PUBLIC INTEREST REVIEW FOR GROUNDWATER APPLICATIONS

SUBJECT: Application G- 17840 Supersedes review of _____
Date of Review(s)

A. GENERAL INFORMATION: Applicant's Name: Jonathan E. and Diane L. Free County: Union

Application G-17840, Jonathan E. and Diane L. Free

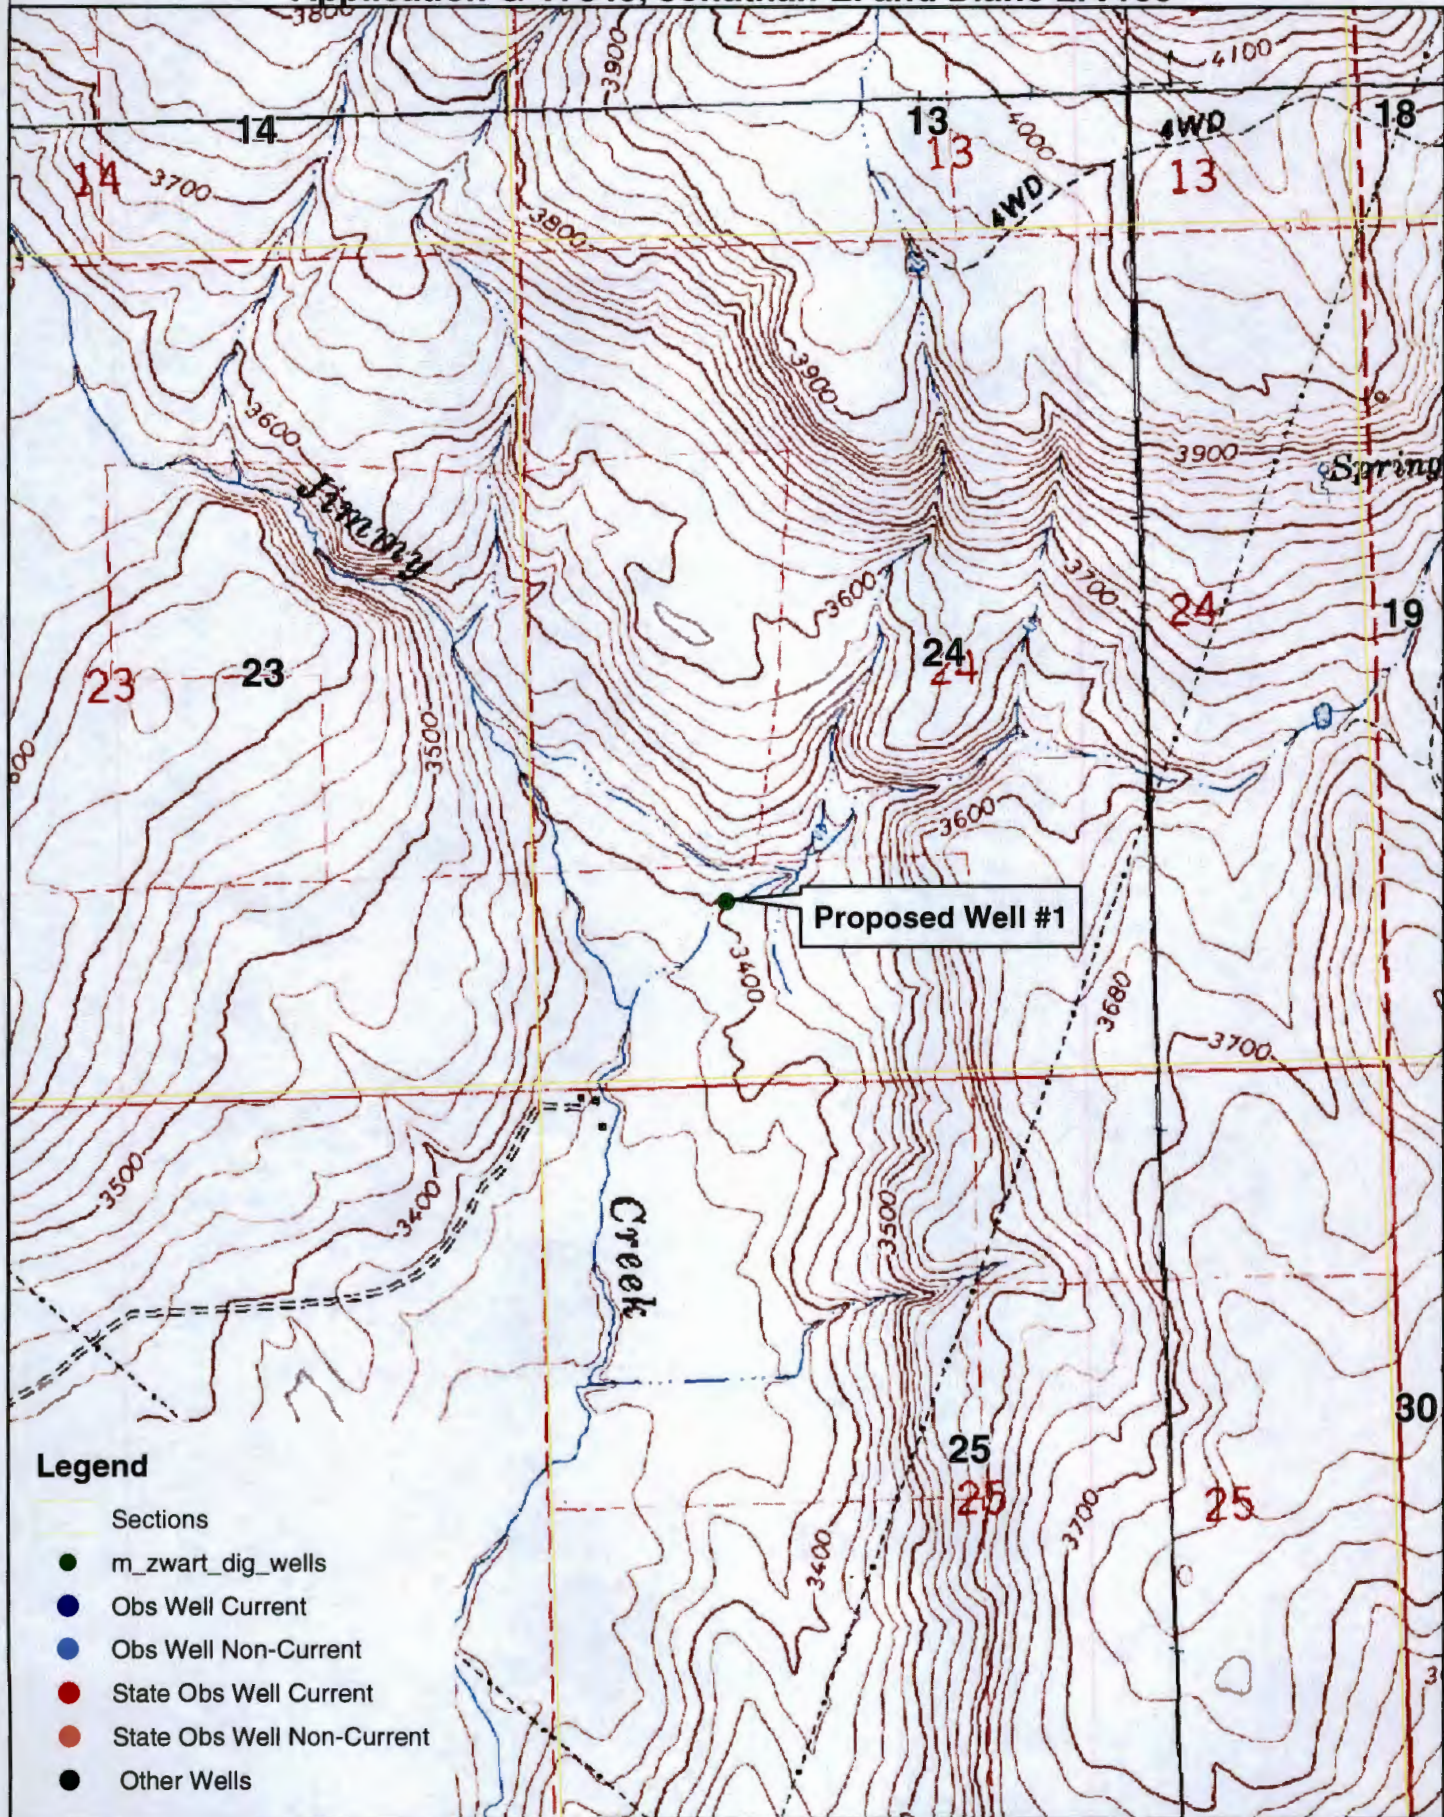
Basis for aquifer hydraulic connection evaluation: The applicant proposes to case and seal the well to 100+ feet or as directed. The proposed seal depth will likely limit hydraulic connection to a reach of Jimmy Creek greater than one mile from the proposed well.
